Project 38 Chester Terrace NW1 4ND

Drawing Title Proposed Rear (East) Elevation

Drawing No. P2102 Rev. C

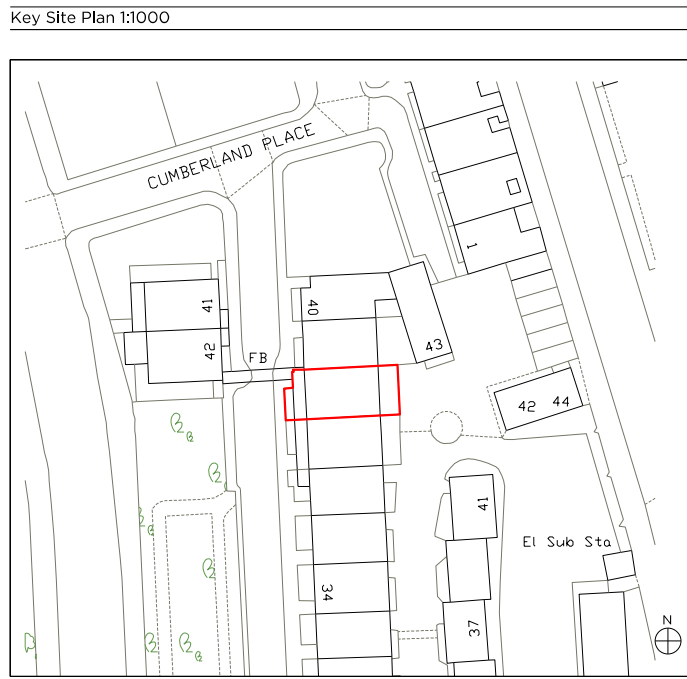
| Revision Notes | | |
|----------------|--|--|
| A.1 | Works to remove existing lower ground floor slab and lower floor level omitted. | |
| A.2 | Proposed door opening reduced as per LBC comment, Proposed opening size reduced to match neighbouring properties. | |
| B.1 | Rear Courtyard layout amended. New staircase to Upper Ground Floor Level added. Proposed built in furniture and planters. | |
| C.1 | Rear Courtyard layout amended. Spa/ condenser units housed in Floor Level added. Proposed built in furniture and planters. | |
| C.2 | New window to match existing. | |
